VILLAGE OF WINDSOR
BOARD RESOLUTION 2018-84

APPROVING CHANGE ORDER #1 FOR THE WINDOSR COMMUNITY PARK IN BEAR TREE SUBDIVISION

REQUEST FOR CHANGE ORDER #1 Revised

Project Name: Bear Tree Park
Location: Windsor
Project #: 18-3-039
Description: Erosion control plan changes

EROSION CONTROL PLAN

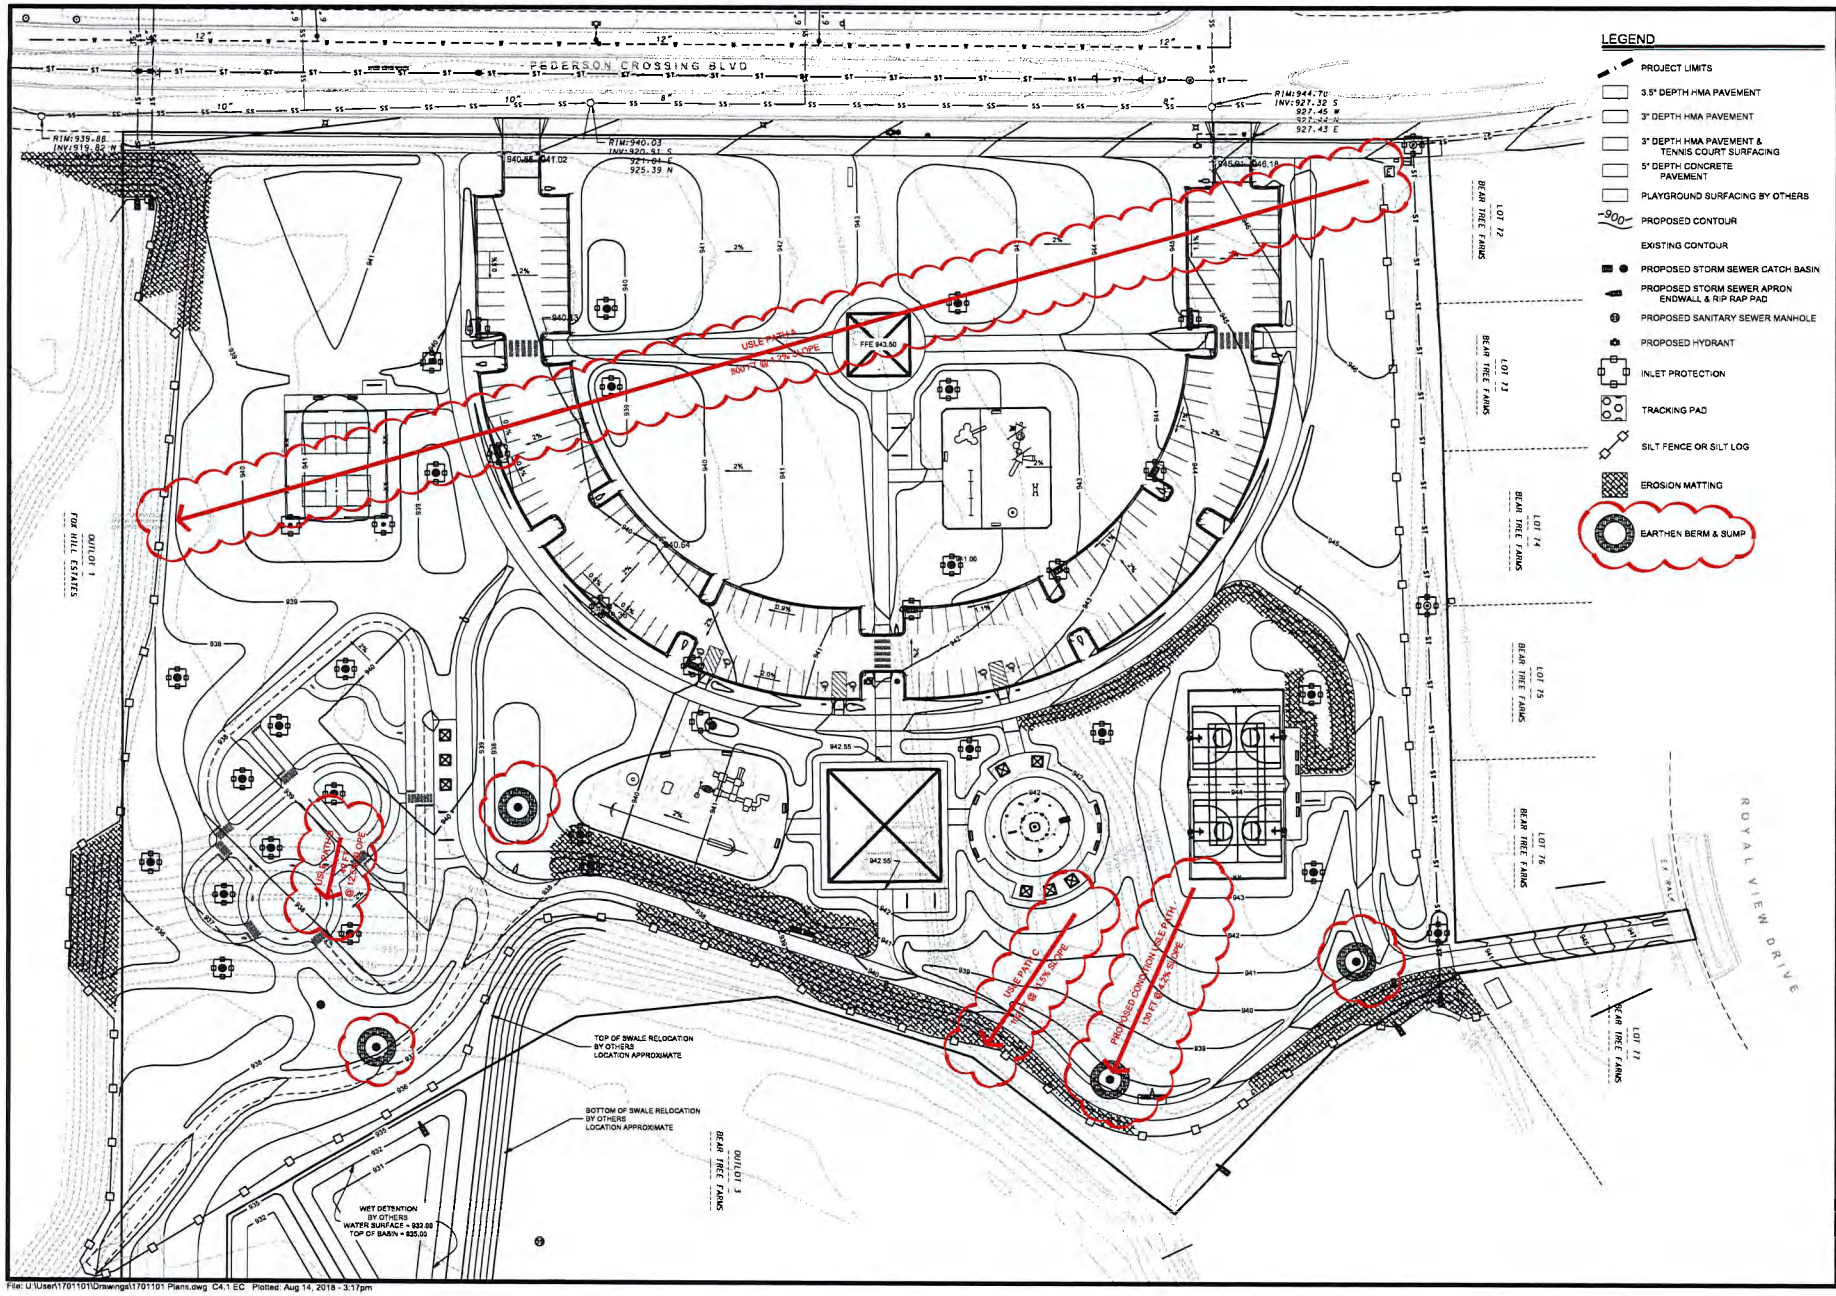
WHEREAS, Dane County, in the review and permitting of erosion control for the site, required the addition of an earthen berm and sump and temporary cover treatment, as needed; and

EARTHEN BERM & SUMP

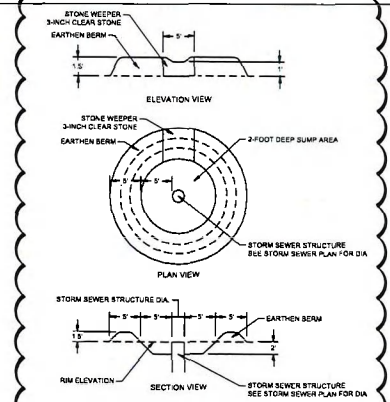
- Erosion control permit supplemental material correspondence date 8/24/2018 (See enclosed)
- Parisi proposed EWR01 dated 8/23/2018 (Earthen Berms Only) $ 4,000.00
- OH & P per article 12-5% $ 200.00

Item No.	Description	Quantity	Unit	Unit Price	Extension
	Earthern berm & sump	4	EA	$ 1,000.00	$ 4,000.00
	Temporary cover treatment - polymer / mulch	50,000	SY	$ 0.25	$ 12,500.00

1. Earthen berm and sump, $4,200.
2. Temporary cover treatment of polymer/mulch at a unit price of $0.15/SY as needed, upon the written directive of Bruce Hollar, Village General Contractor, and paid only for the amount actually placed.
